SITE PROBLEM REPORT
RESOLUTION TRANSMITTAL

File: 13- 06 - 183
Contract No.: 620-00 06
SPR Number: 153 1000
Title: Re-RV2 Failure
Down Reactor T2 & E
Status Code: R
Date Of Transmittal: 2/20/79

| Project Name IC-1-2 Failed Under Reactor Trip I | | Problem Contact S. P. Wagner 2/12/79 |

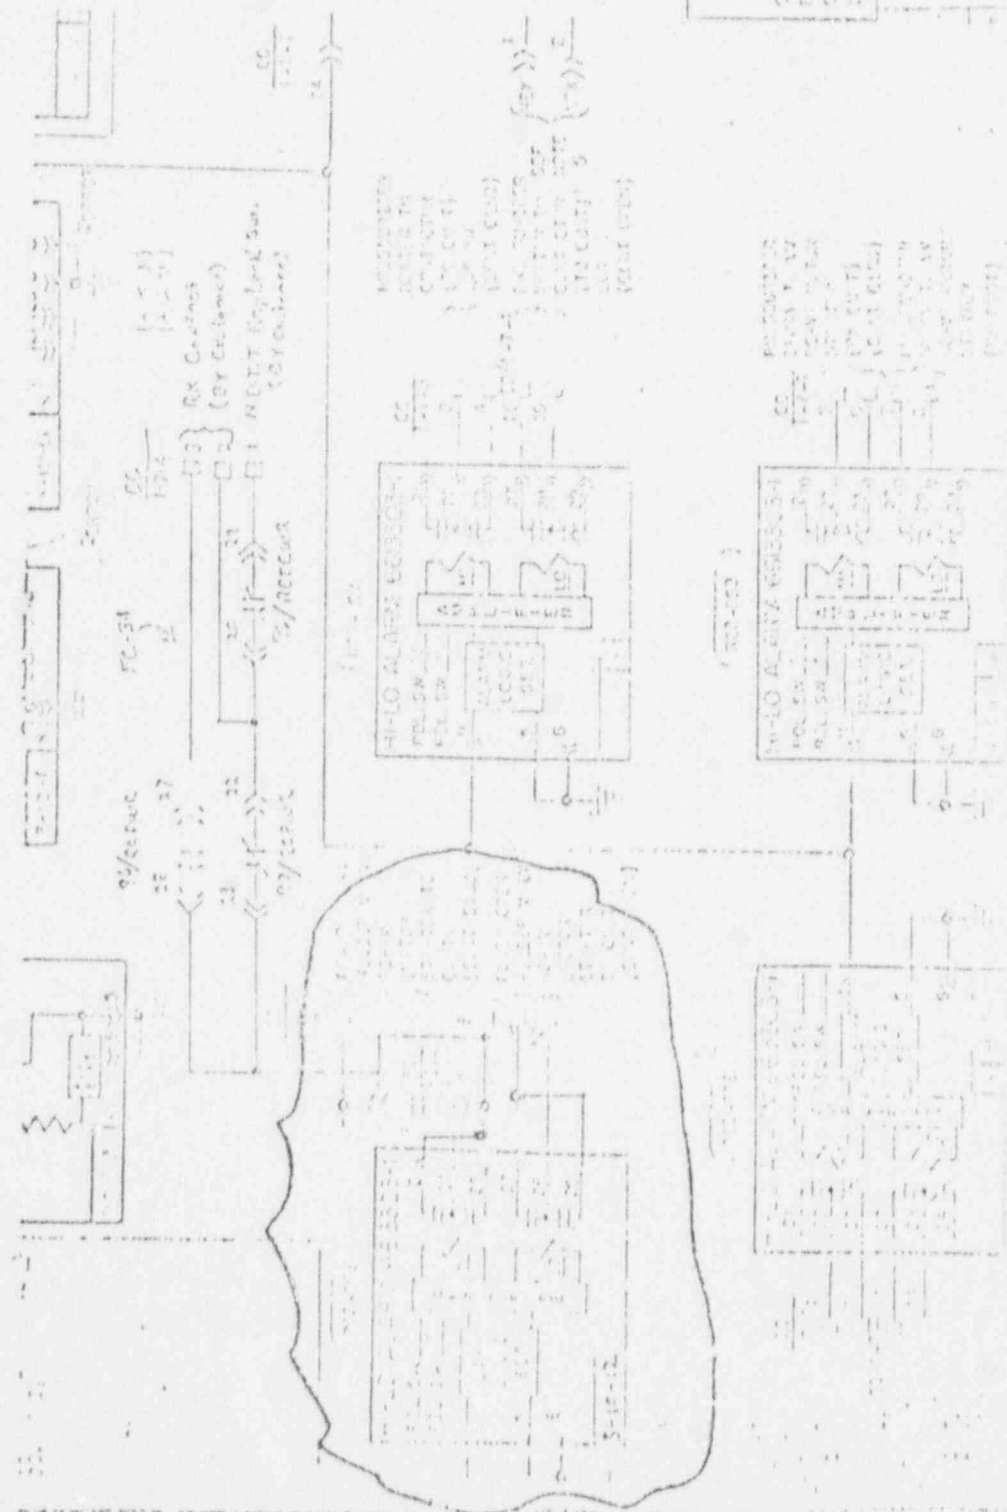
The electronic relief valve opens on loss of power to its control bytable. Suggest changing this or providing an indication on Control Panel that indicates valve has an open signal.

BEW has reviewed the electromagnetic relief valve logic and agrees to the concept of having relief valve fail closed on loss of HMI power supply to the Hi-Low Monitor (3-10-12). To achieve this condition, switch S-1 should be in the deenergized mode and the wiring modifications be made as indicated in the attached sketch. Per your request, a formal field change will follow.

To provide an indication that the electromagnetic relief valve has an open signal, a review of the construction schematics indicates that a control room indicating light operated from power to the solenoid can be added without additional cabling. (Refer to H&B drawing #3079, sheet 14.) This light could be actuated by the same auxiliary relay in the power distribution panel that supplies power to the valve solenoid.

1. Change Switch S-1 position to deenergized in module 3-10-12
2. Lift lead from pin 23 of module 3-10-12 and connect to pin 21
3. Lift lead from pin 27 of module 3-10-12 and connect to pin 29
